Access Compliance Report

Public Rights-of-Way

Intersection ID: 19320	Main Street: COURT_DR	Cross Street: ROCKY_FALLS_RD	Location: NW
ADA ID: B9F17D541E70	Ramp Type: BlendTrans1	Initial Pass/Fail: Fail	Overall Compliance: No
			Severity Score: 21.25

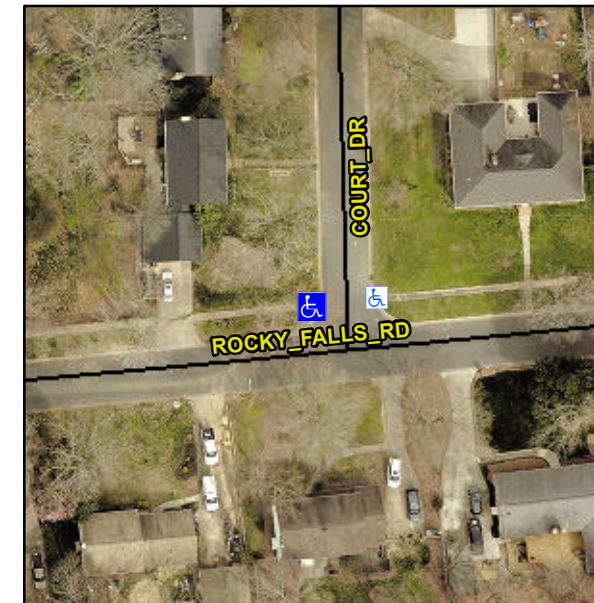
Not Found, R304.5.1, R304.5.3

Compliance	Description	Data	Compliance	Description	Data
N/A	Ramp Length (in)	67.0	Yes	BlendTrans Slope (%)	2.8
No	Ramp Width (in)	44.0	No	BlendTrans XSlope (%)	5.1
N/A	Flare Type LT	N/A	N/A	Flare Type RT	N/A
N/A	Flare Slope LT (%)	N/A	N/A	Flare Slope RT (%)	N/A
N/A	Flare Traversable LT?	N/A	N/A	Flare Traversable RT?	N/A
N/A	Landing Length (in)	N/A	N/A	DWS Provided?	N/A
N/A	Landing Width (in)	N/A	N/A	DWS Contrast?	N/A
N/A	Landing Slope (%)	N/A	N/A	DWS Length (in)	N/A
N/A	Landing X Slope (%)	N/A	N/A	DWS Full Width?	N/A
N/A	Landing Curb? (Y/N)	N/A	N/A	DWS Offset (in)	N/A
N/A	Shared Landing?	N/A			
N/A	Gutter Ponding?	N/A	N/A	Gutter Slope (%)	N/A
N/A	Gutter Lip Ht (in)	N/A	N/A	Gutter X Slope (%)	N/A
N/A	Painted X Walk1?	No	N/A	Painted X Walk2?	No
	X Walk 1 Direction	To S		X Walk 2 Direction	To E
	X Walk 1 Width (in)	N/A		X Walk 2 Width (in)	N/A
	X Walk 1 Slope (%)	0.6		X Walk 2 Slope (%)	5.2
	X Walk 1 X Slope (%)	8.1		X Walk 2 X Slope (%)	0.5

N/A	Ramp inside XWalk1?	N/A	N/A	Ramp inside XWalk2?	N/A
	Road Slope (%)	2.8		Clear Space?	N/A
	Road X Slope (%)	8.6	N/A	Clear Space to XWalk (in)	N/A
N/A	Any Obstructions?	N/A	N/A	Storm Grate/Utility Hazard?	N/A
	Obstruction Type			Storm Grate/Utility Type	
		N/A			N/A
			Yes	Surface Condition? (G/P)	Good
			No	Curb Slope (%)	7.9

Remove & Replace Curb Ramp With Two New Directional Ramps or Equivalent.
